STAFF REPORT

SUBJECT: FP-2020-0003
Quartet Northeast No. 1

Final plat consisting of 72 buildable lots & 11 common lots on 26.4 acres of land in the R-4 zoning district.

D. Common Driveway Exhibits

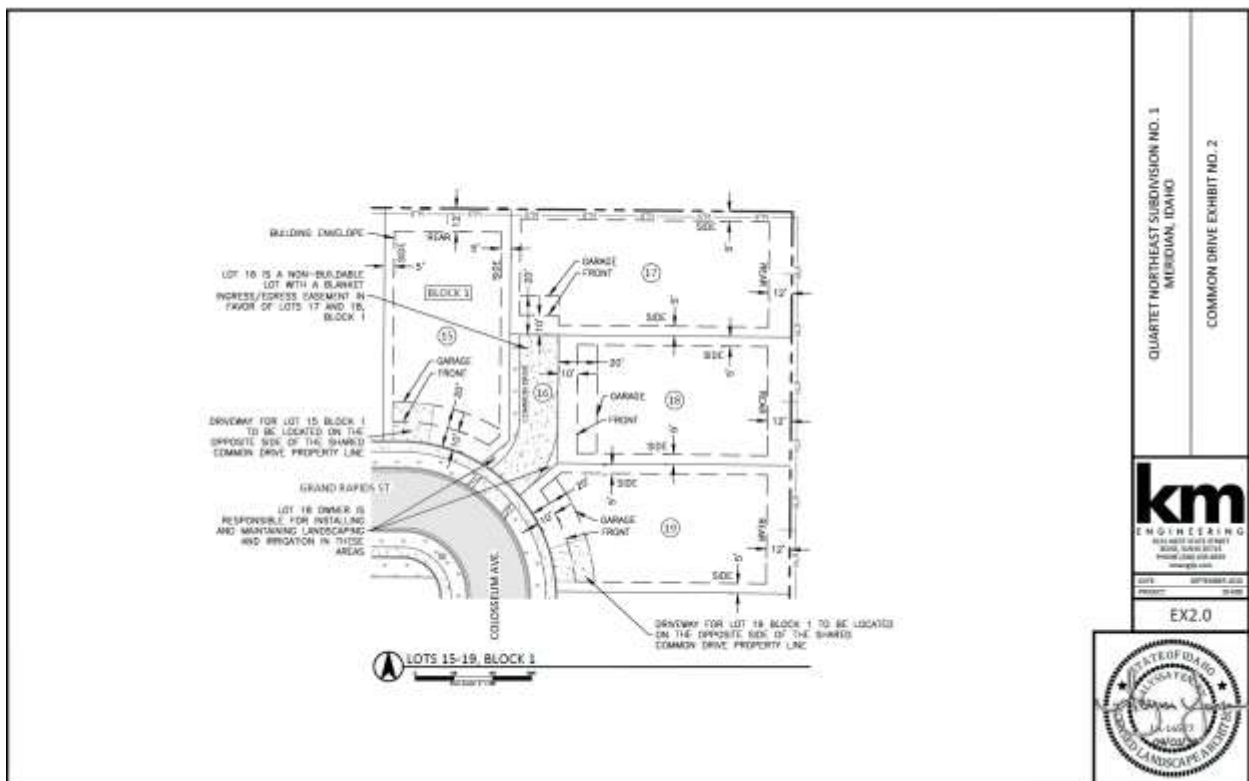
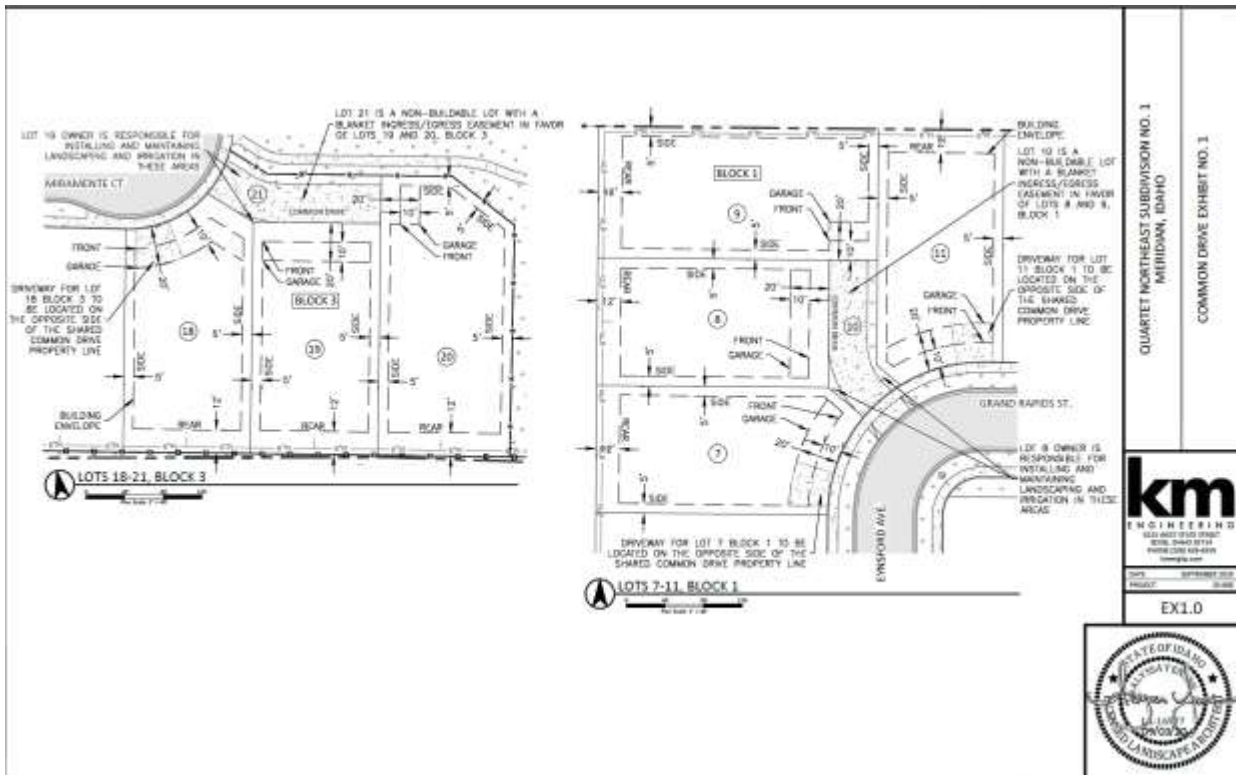
- c. Depict the location of the swimming pool and children's play equipment on Lot 9, Block 4; include a detail of the play equipment.
6. Construction of the common driveways on Lots 10 and 16, Block 1, and Lot 21, Block 3 shall comply with the standards listed in UDC 11-6C-3D and with the exhibits in Section V.D.
